CITY PLANNING COMMISSION

- APPLICATION:**
- A. Negative Declaration
 - B. Plan Review of three warehouse/office buildings totaling 174,888 square feet on 9.3+ vacant acres in the Light Industrial-Review (M-1(S)-R) zone
 - C. Lot Line Adjustment to relocate the common property line of 4 lots totaling 19.24+ vacant acres in the M-1(S)-R zone

LOCATION: Southeast corner of Raley Boulevard and Santa Ana Avenue

P89 120

STAFF MODIFIED SITE PLAN

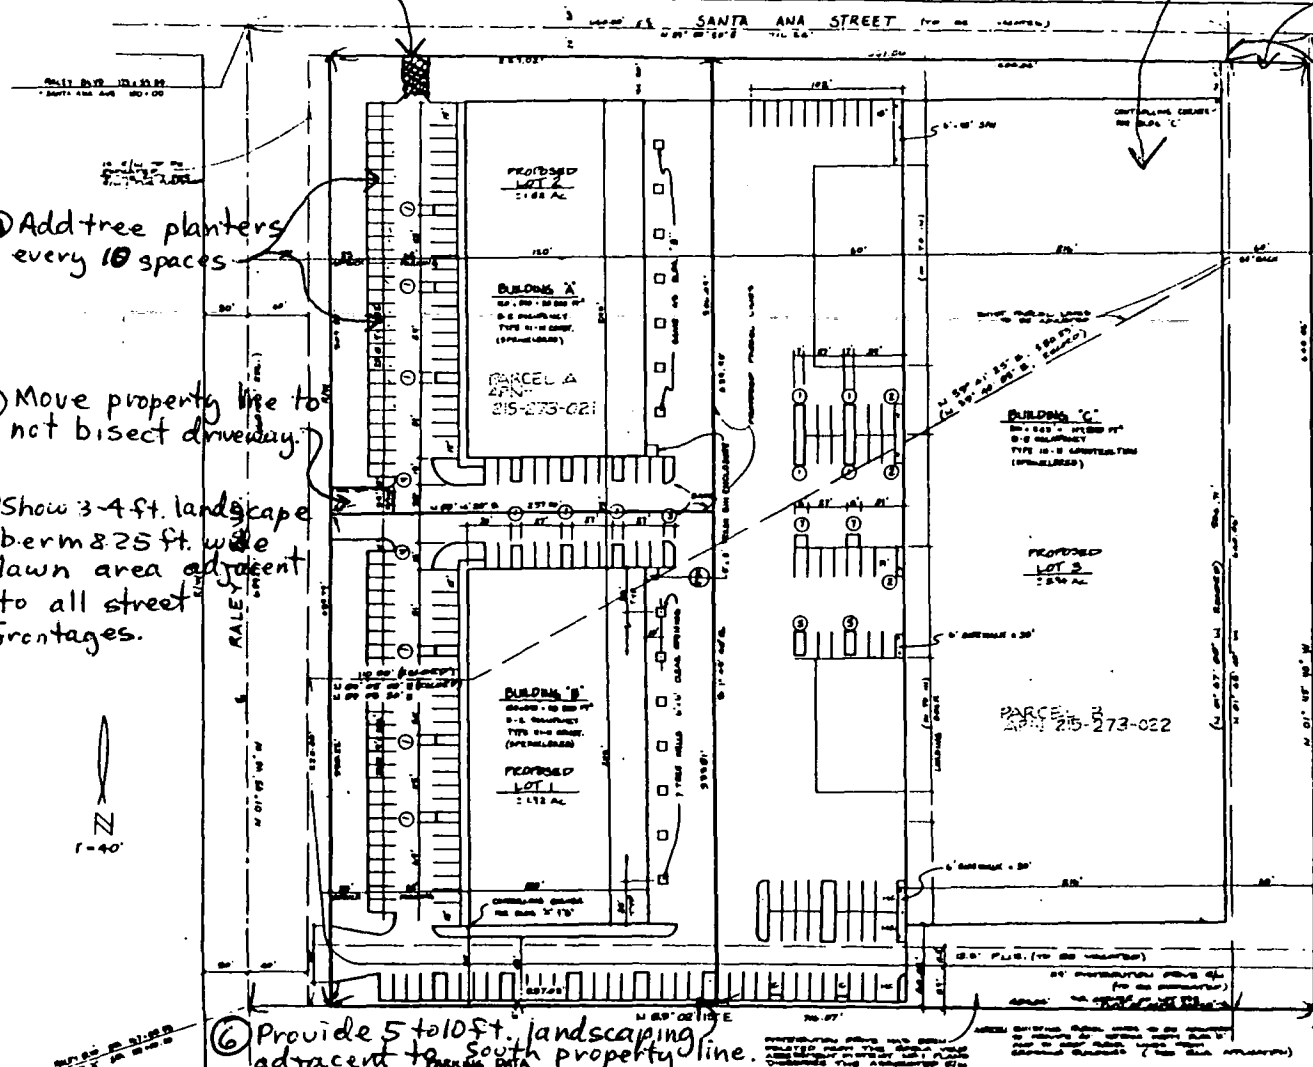
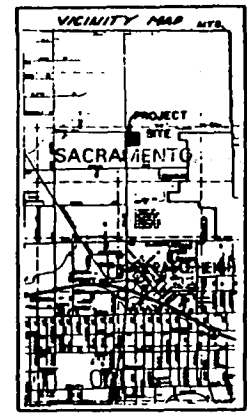
① Provide turf block emergency fire access to Santa Ana.

② Add 2 trash enclosures for Bldg. C.

③ Provide access to Rear of Bldg. C.

⑦ Screen fence around all outdoor storage.

③ Add tree planters every 10 spaces

④ Move property line to not bisect driveway.

⑤ Show 3-4 ft. landscape berm & 25 ft. wide lawn area adjacent to all street frontages.

⑥ Provide 5 to 10 ft. landscaping adjacent to South property line. Relocate parking

RAYLEY BLVD. BUILDINGS 'B'
ELEVATIONS AND SECTIONS
PANATION DEVELOPMENT CO. CITY OF SACRAMENTO, CA

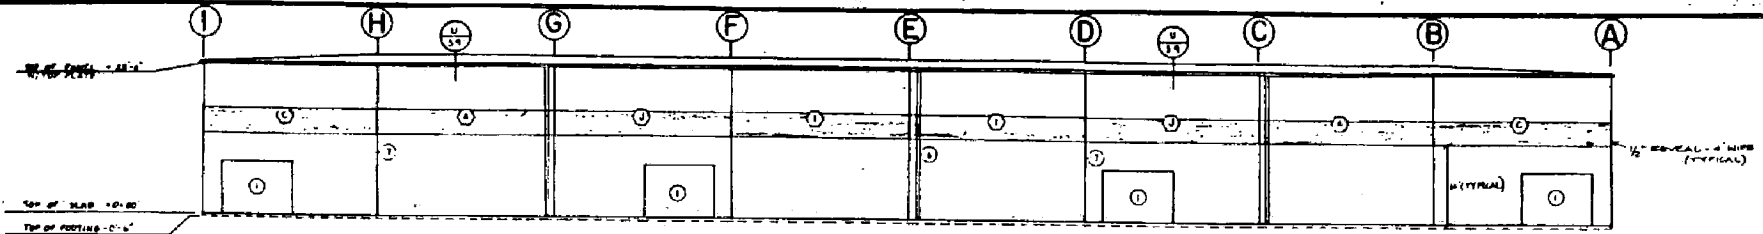
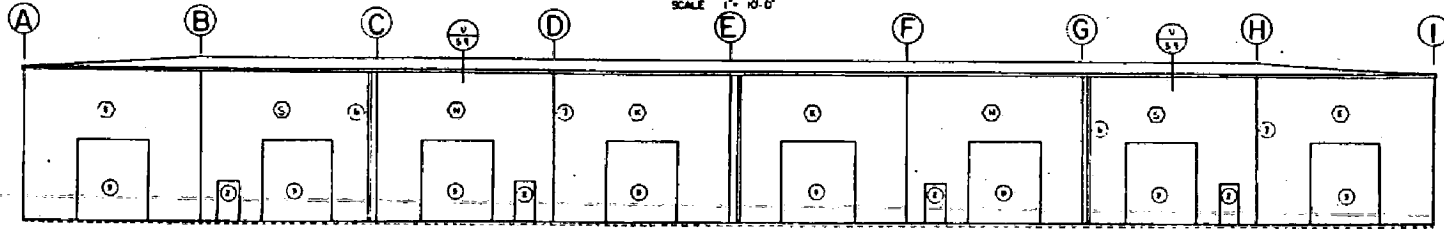
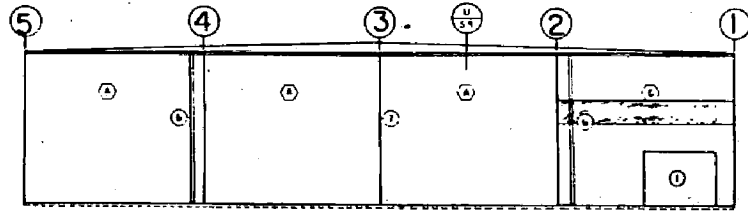
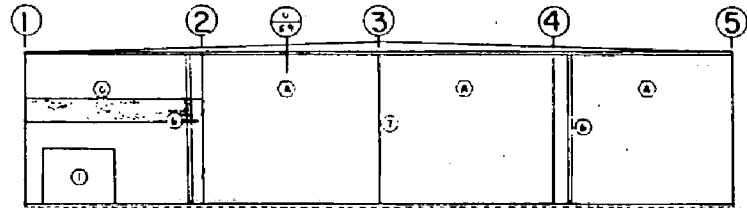
Regarding the store front window system, the applicant has agreed to modify the front elevations of buildings A and B to reflect more variety through the use of four, four inch wide, one inch deep reveal lines placed equidistant along the top half of the wall sections and wrapped around the ends of the building. The addition of columns and recessing the window system into the building is proposed. Staff recommends that these revisions to the elevations be reviewed and approved by the City Design Review Coordinator prior to issuance of building permits.

2. The applicant shall revise the exterior elevations to the satisfaction of the City's Design Review Coordinator and Planning Director. All proposed colors are to be included in the revised elevations.
